**From:** Sam Glossop  
**Sent:** Tuesday, October 31, 2023 8:59 PM  
**To:** Megan O'Mara  
**Subject:** Re: The cranny North Yorkshire

I will try to call tomorrow, but please find the info on the range yorkshire surround renewal

**NYMNPA**  
 31/10/2023

PLAN and elevation view 1:20

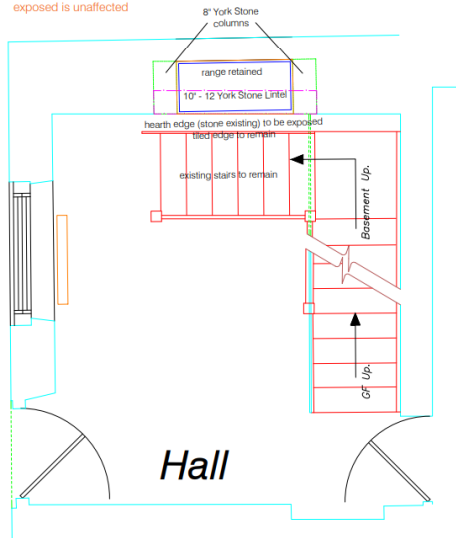
The photo shows the fake stone frontage had the top lintel flush with the upright stone

- The stone uprights will be 8 inches

- To maintain ratio the lintel will be 10-12 inches

- The drawing shows 12"

EXISTING HEARTH UNAFFECTED AND REMAINS UNDER THE EXISTING RANGE COOKER - LEAVE FRONT EDGE FULLY EXPOSED

The stairs can remain as agreed in the same location - the range being exposed is unaffected

PLAN and elevation view 1:20

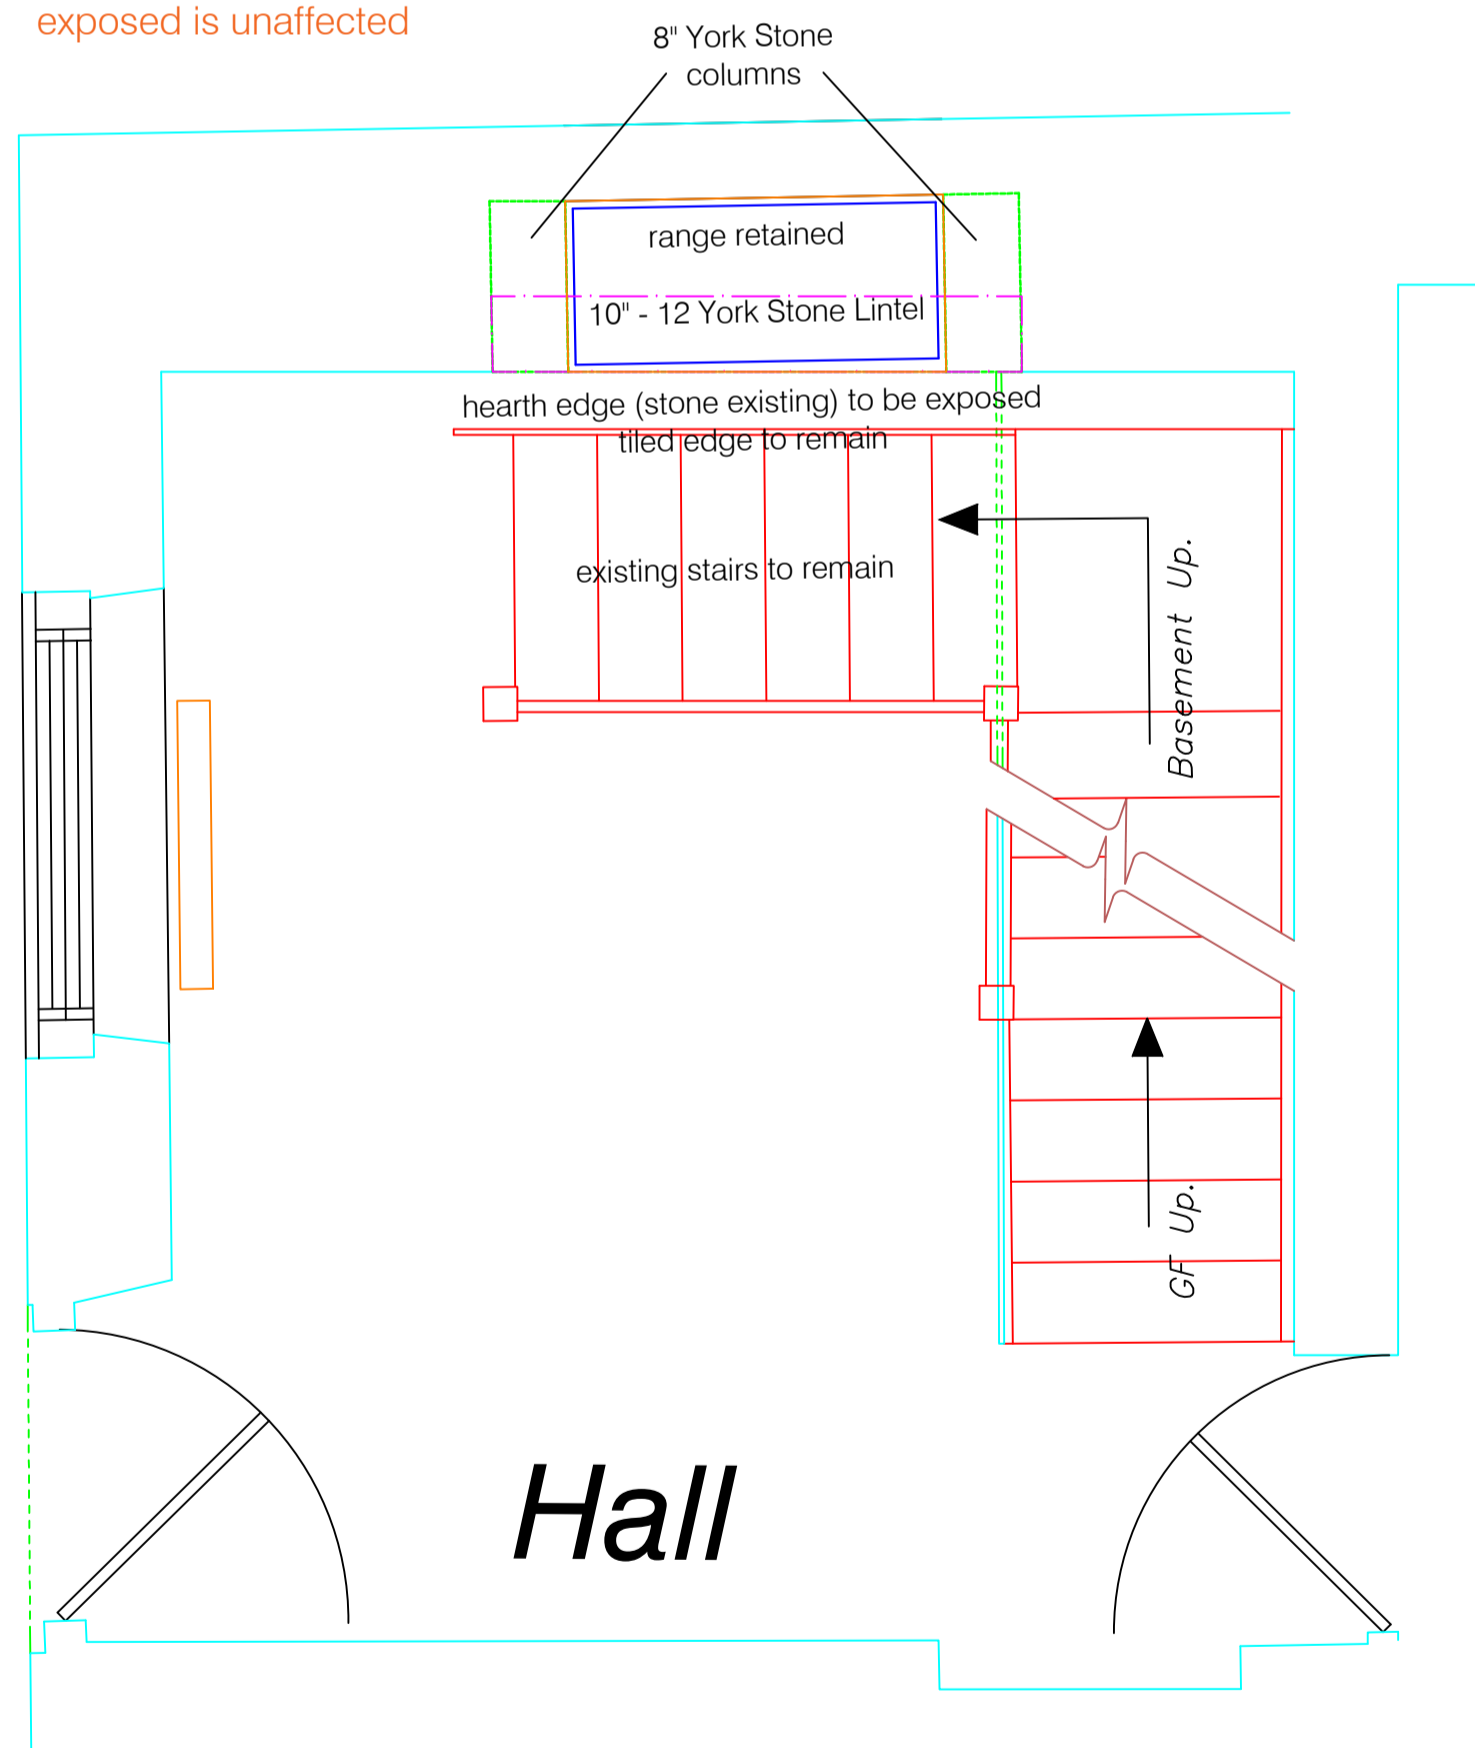
EXISTING HEARTH UNAFFECTED AND REMAINS UNDER THE EXISTING RANGE COOKER - LEAVE FRONT EDGE FULLY EXPOSED

The stairs can remain as agreed in the same location - the range being exposed is unaffected
